RE: Valle de Atrisco Apartment Development Grading and Drainage Plans and Drainage Management Plan Stamp Date: 9/29/17 Hydrology File: P09D002D

County of Bernalillo Case Comments Report

To:Don Briggs, BC PWDFrom: Nicole Friedt, AMAFCADate:October 18, 2017Re:AMAFCA Comments for PWDN 20170080

Valle De Atrisco Apartment Development

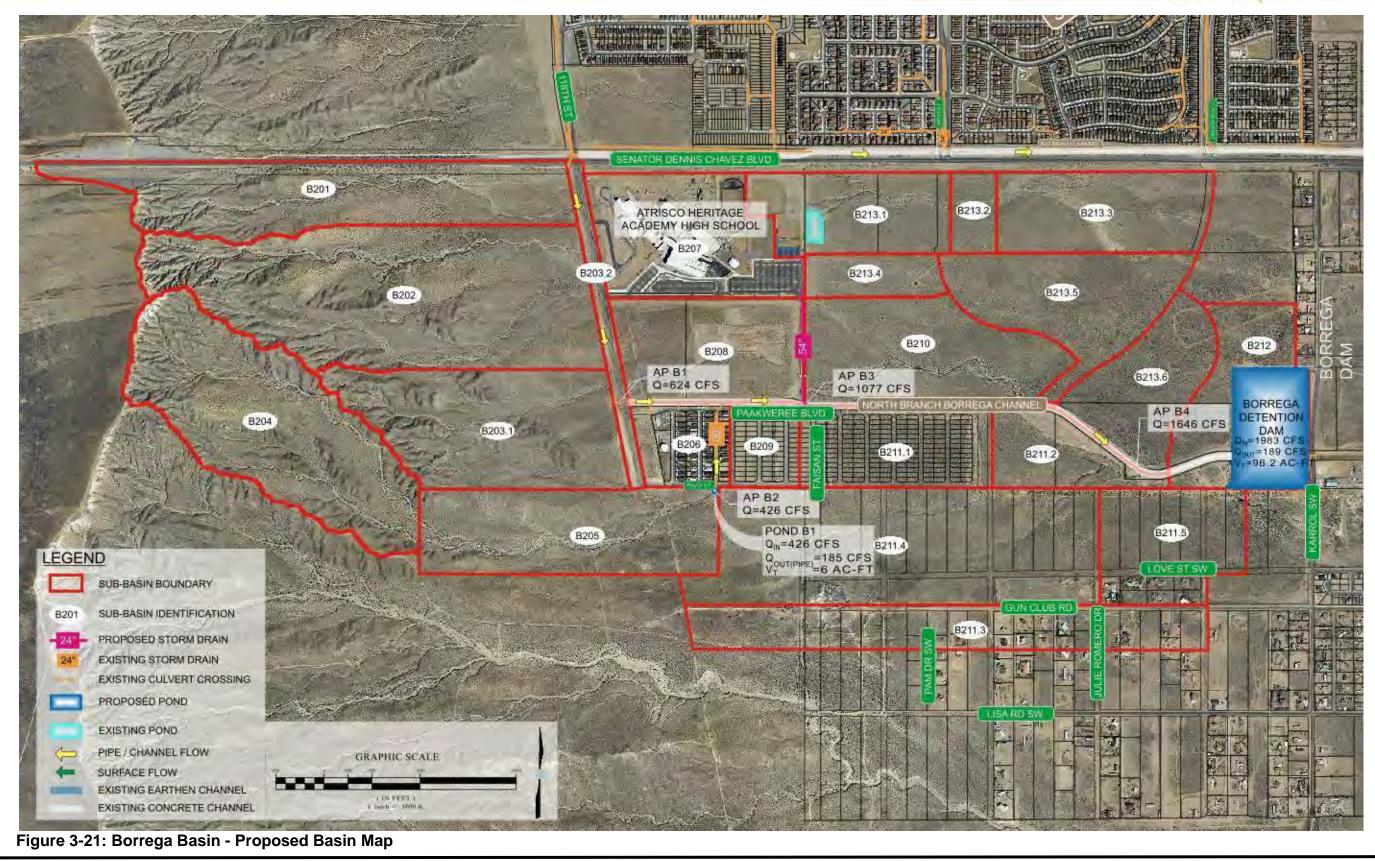
- 1. Provide computations showing how the peak discharge and volumes from the proposed development will be controlled to remain in conformance with those shown in the Amole-Hubbell Drainage Master Plan, dated November 2013 for Basin B213.1? (See attached information for B213.1)
- 2. If the developer would like free discharge from this site, identify what permanent facilities will be put into place to control flows to those identified in the master plan prior to discharging into the Borrega Channel near the anticipated future Unser Blvd. Crossing? (shown in the attached flow chart as the summary of basins B213.1, B213.2, B213.3, B213.4, and B213.5)

GRADING & DRAINAGE PLAN - OVERVIEW

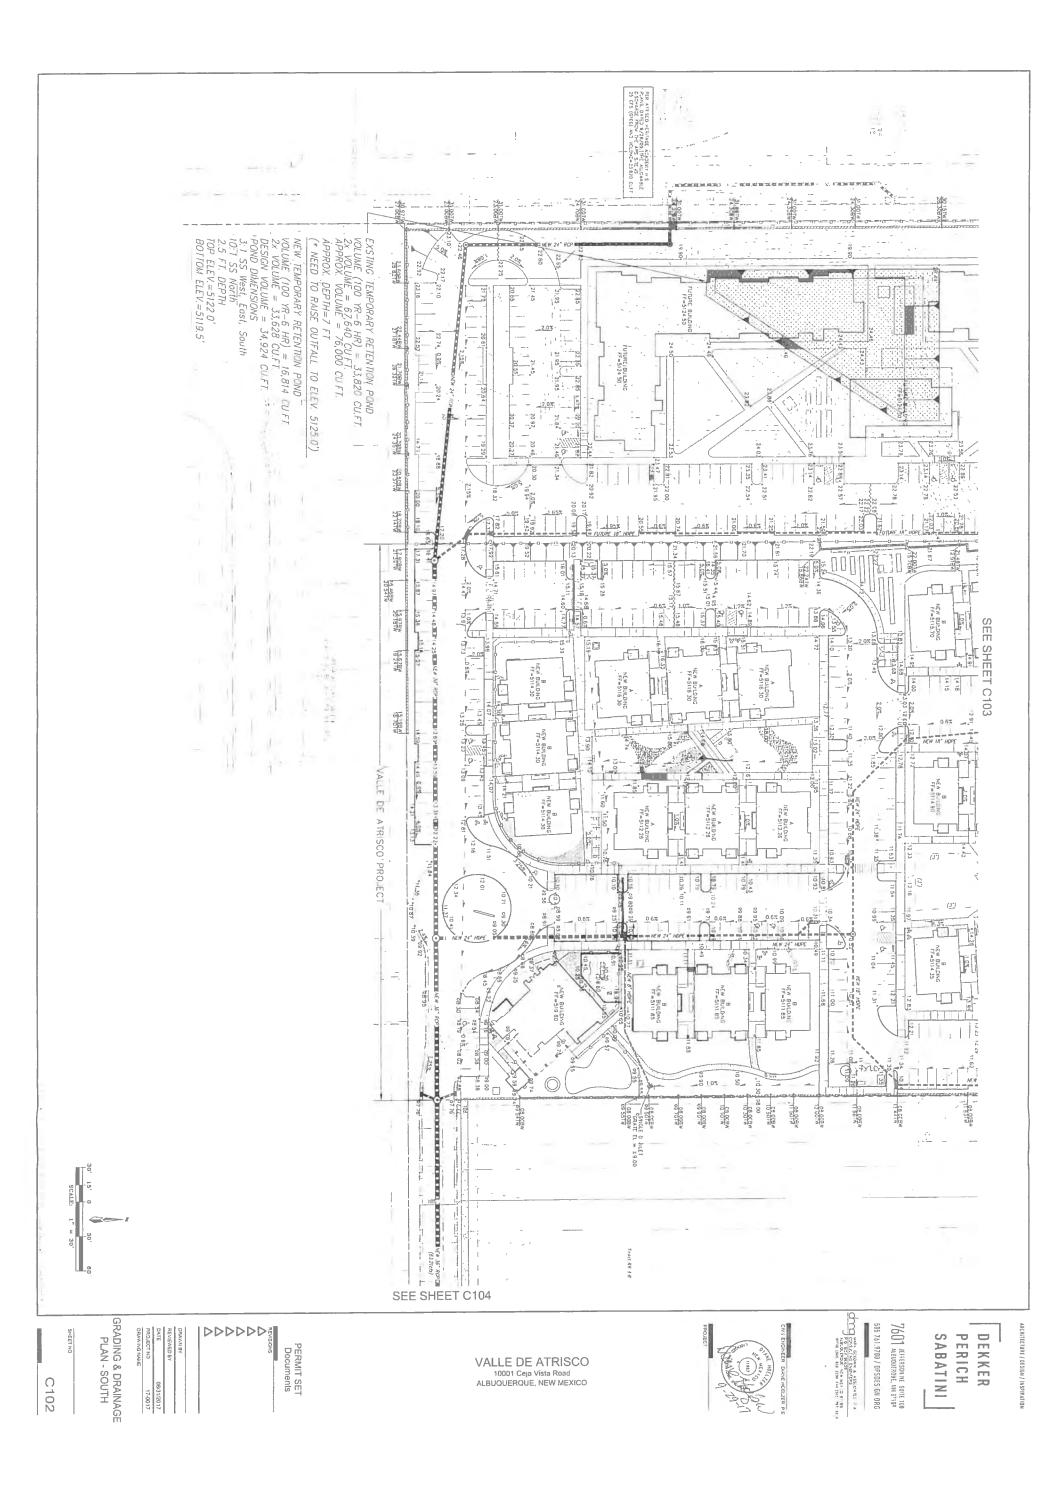
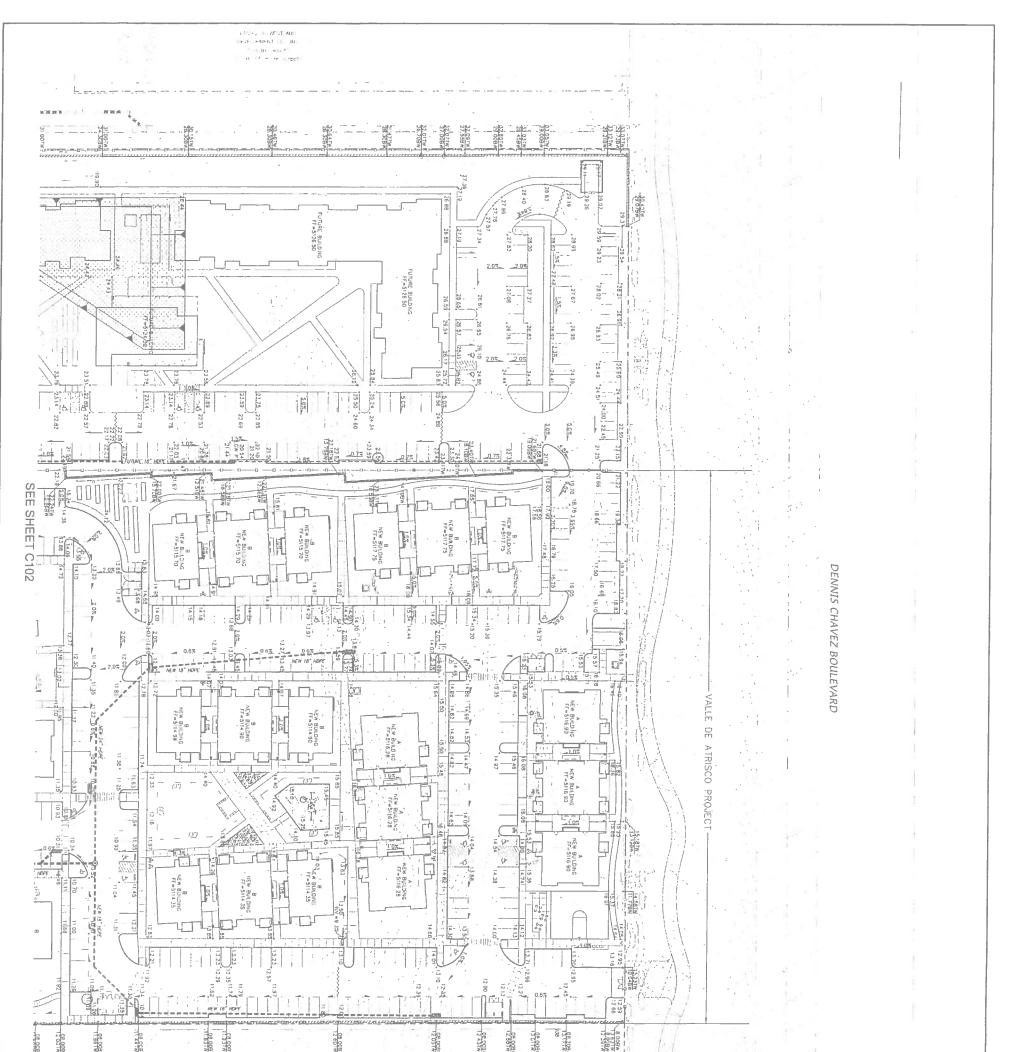
4. Sheet C-101. Please turn off all notes not associated with this sheet. There are several places with retention pond information lettering size is too small.

5. Sheet C-101, C-102, & C-104. Please turn off all non-related future projects in the County. Also please work with the layering. The future project on Tract RR-3-A-1 should not be the same line thickness as the proposed apartment development and proposed public infrastructure. Only show improvements that will actually be constructed prior to Certificate of Occupancy.

6.	Sheet C-101. The permanent drainage solution in 98th Street & Denis Chavez must be designed and constructed with this project. The temporary retention pond west of 98th Street is not acceptable, permanent infrastructure is required. Please add Drainage Basins and drainage analysis for both 98th Street & Denis Chavez.

7.	Sheet C-101 & C-102. Please add a note stating "temporary retention pond needs to be complete prior to Hydrology's approval of the Certificate of Occupancy." to the temporary retention pond on Tract RR-3-A-1.

8.	Sheet C-101. Please clearly indicate the public infrastructure to be constructed in the DRC work order construction plans. And label "To be constructed under a DRC work order prior to Certificate of Occupancy."

9.	Sheet C-101. Please show and label the permanent drainage easement for the off- site temporary retention pond and open channel including recording information.
10	Sheet C-102. Please fix the text height for the notes about the existing temporary retention pond and the proposed temporary retention pond.
